**RE: 1446 NW 53<sup>rd</sup> St Mixed Use – Project Completion**  
**DPD Project No: 66391152**

We present an overview of structural observations of the project at 1446 NW 53<sup>rd</sup> St in Seattle, WA for your review. Structural observation, as required in Section 1704 of the Seattle Building Code, has been performed on this project.

## Field Report

At your request, we were on site at the project located at 1446 NW 53<sup>rd</sup> Street on Wednesday, February 15, 2023 to perform structural observations of the wood framing levels and review items noted in the special inspection report dated 02-01-2023 provided by Otto Rosenau and Associates.

SSK-13: Shear wall anchor bolt washer requirements  
EAF/Frank Co.  
02-16-2023

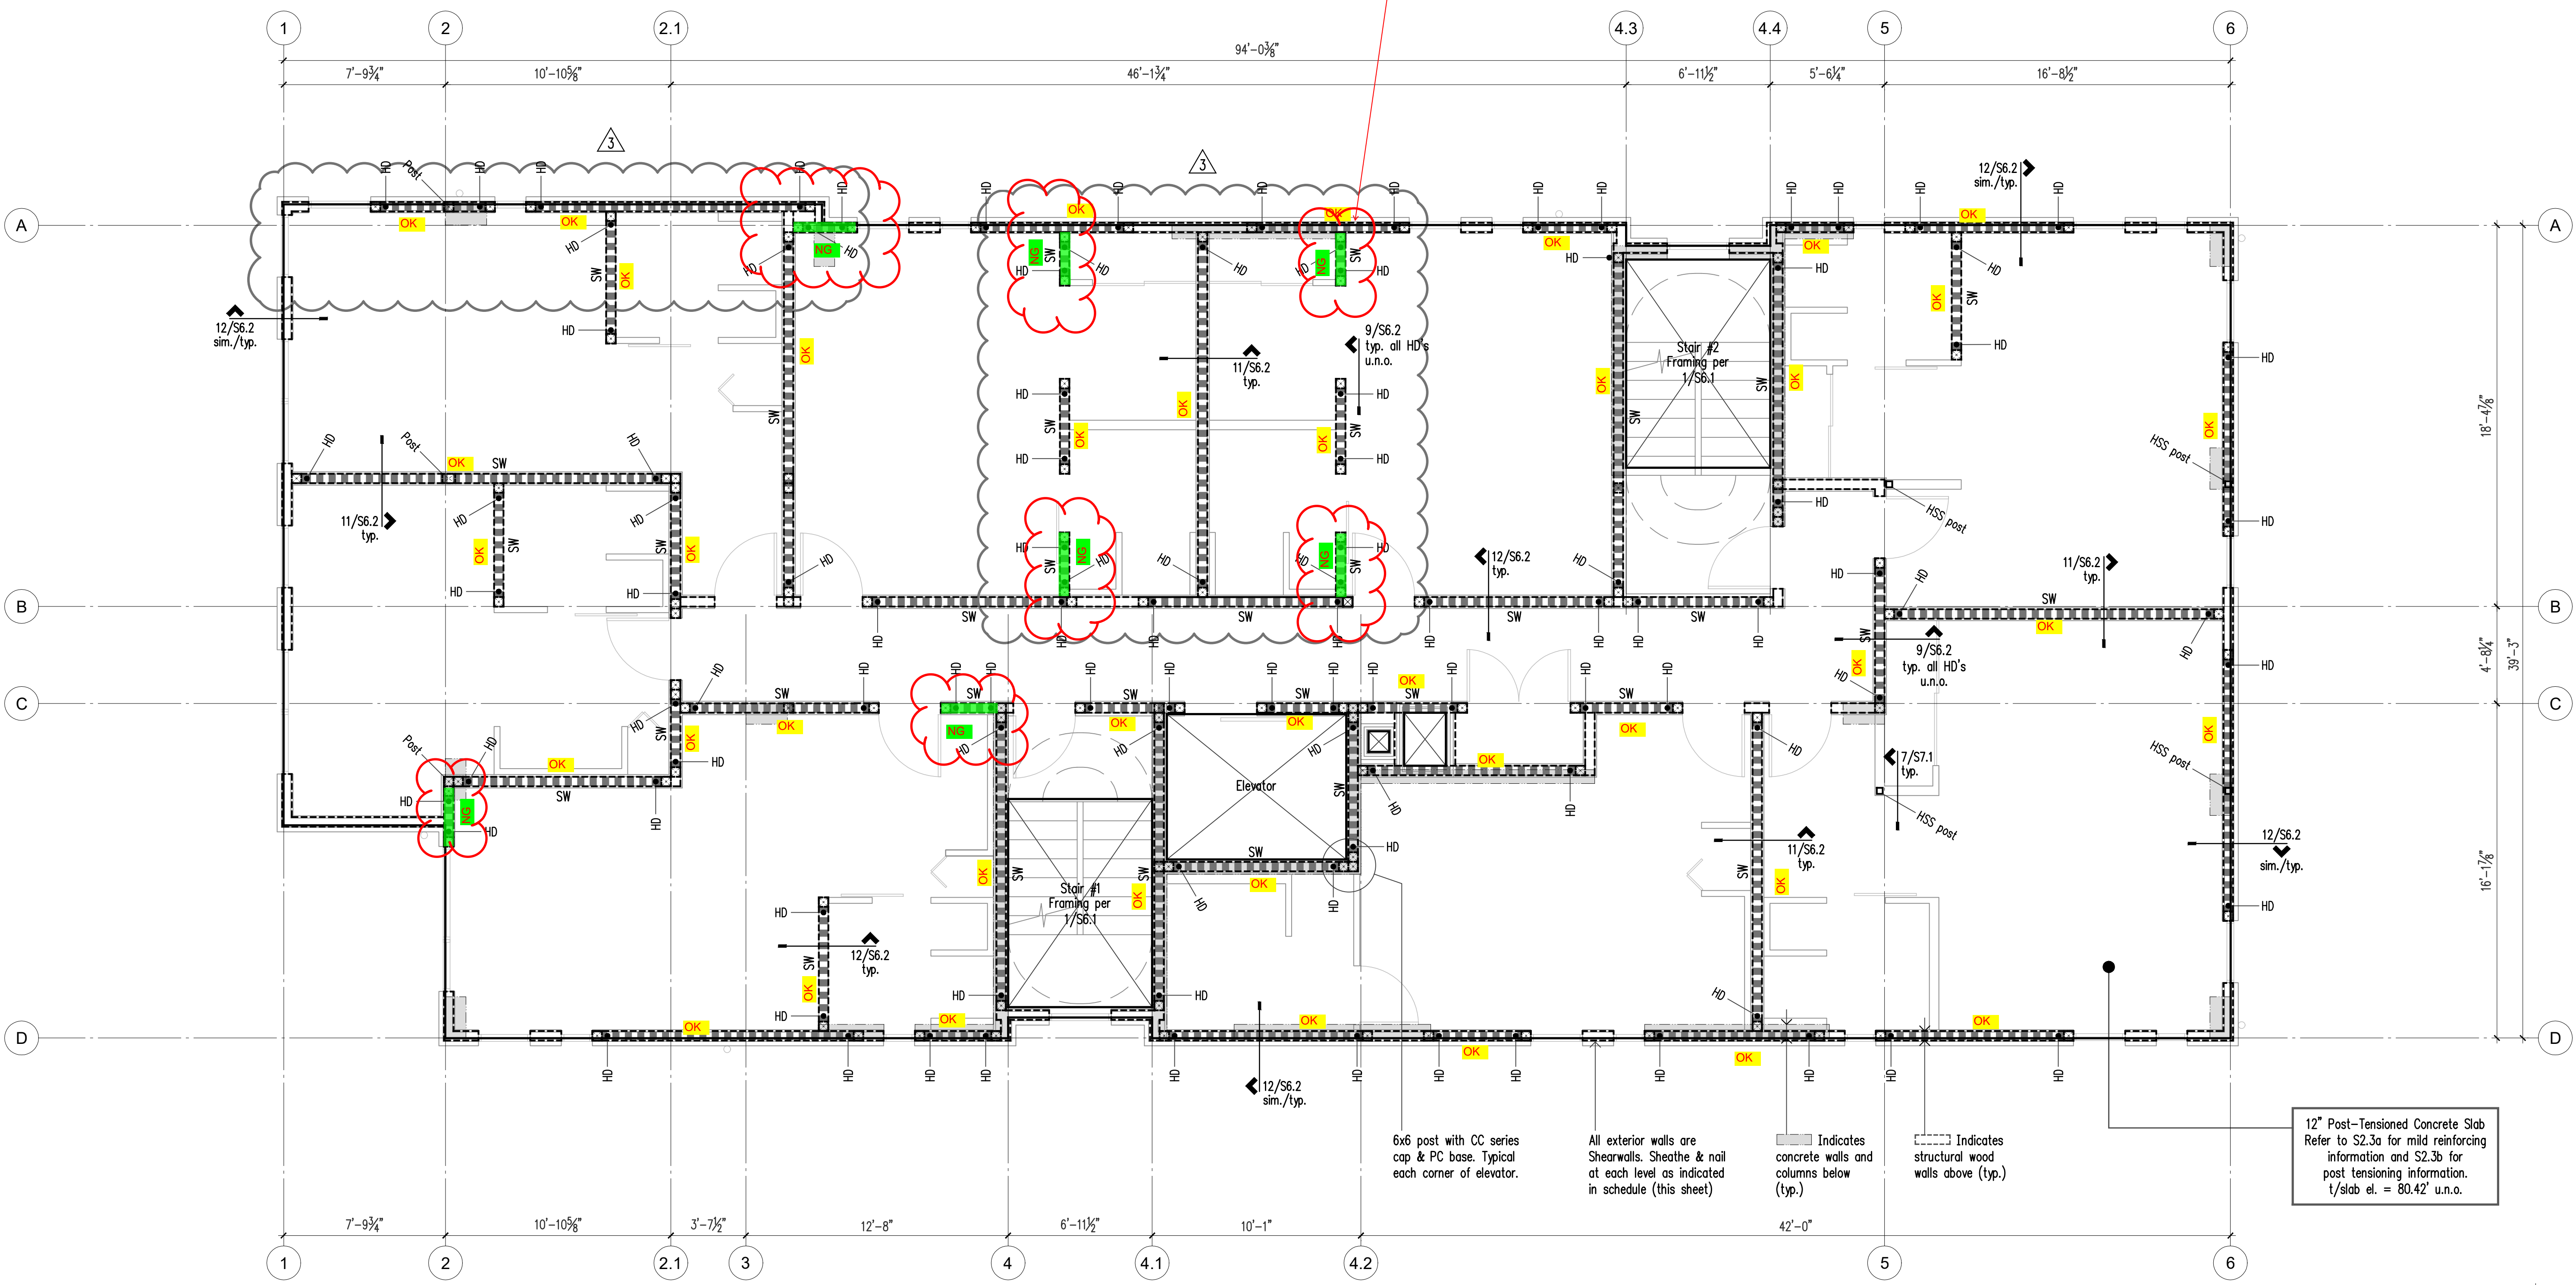
18. The condition was evaluated at the PT slab level, and the criteria for meeting the exception to the requirement for the plate washer within 1/2" of sheathed edge of the walls are met in all but the

locations provided in SSK-13 attached. Plate washers within 1/2" of sheathed edge are required at the locations noted in SSK-13.

CLOUDED LOCATIONS HILIGHTED  
IN GREEN ARE REQUIRED TO HAVE  
PLATE WASHERS WITHIN 1/2" OF  
THE EDGE OF THE BOTTOM PLATE  
ON SHEATHING SIDE OF THE WALL.

## SSK-8 BLOCKING AND NAILING AT INTERIOR SHEAR WALLS

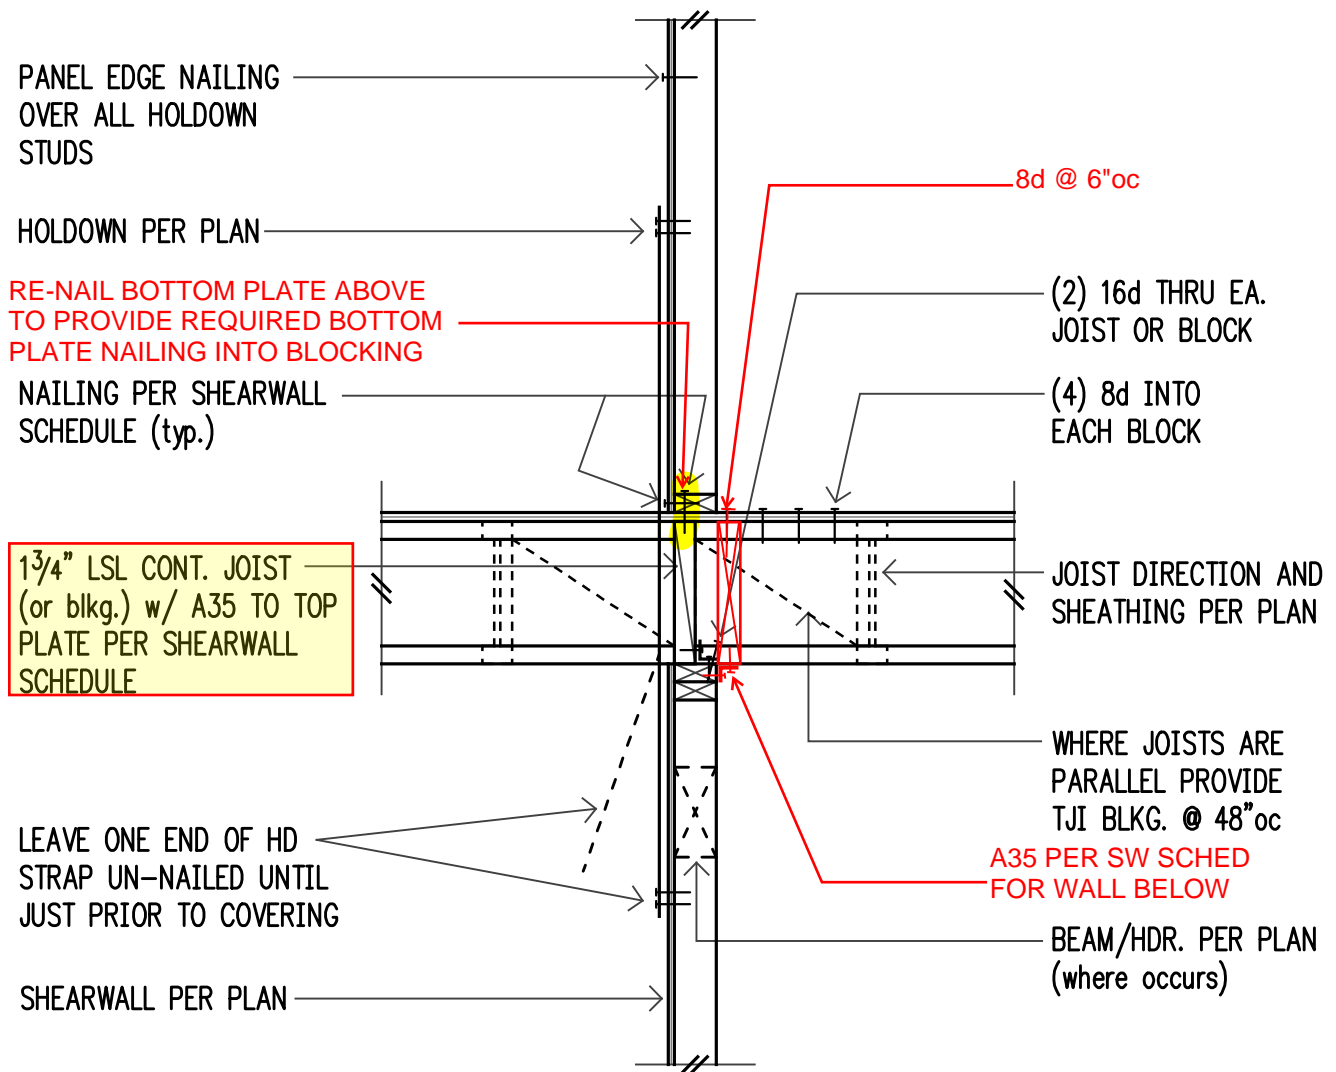
19. All slotted anchor bolt washers need standard round cut washers between nut and slot.
20. Some interior shearwalls have no room for anchor bolts. Engineer's direction needed where room does not exist.
21. Upper and lower top plate cord splices are not 6'0" apart as required. Some are 2'0" apart and happen above king studs.
22. Nailing of upper and lower top plates incomplete at cord splices, 2/S6.1.
23. Drilled and bored holes in plates and studs need reinforcing per engineer's detail.
24. LSL at interior drag struts, 2-2.1/A-B, do not bear on shearwalls below.
25. (2) 1-3/4" LSL required at exterior walls where contractor placed only (1) 1-3/4" LSL at above windows only.
26. TJI used for rim blocking are not fastened to wall top plates as required.

19. Washers shall be added by GC and confirmed by Special Inspector.
20. Anchor bolts were added by GC. Special Inspector to confirm.
21. Direction was provided to GC for a CS16 strap added across all splices not meeting criteria. Special Inspector to confirm installation.
22. Nailing to be completed by GC and Special Inspector to confirm.
23. A stud shoe shall be added at studs drilled for plumbing in non-bearing shear walls. Plate strapping requirements are noted in detail 7/S6.3.
24. Where LSL not installed over interior shear walls, SSK-8 was provided for corrective action. Special Inspector to confirm installation.
25. Double rim is provided for fire-rating, not structural purposes. Arch to provide direction.
26. TJI rim blocking is acceptable at Level 7, only. LSL/LVL blocking to be added at all other levels with correct nailing per SW schedule.
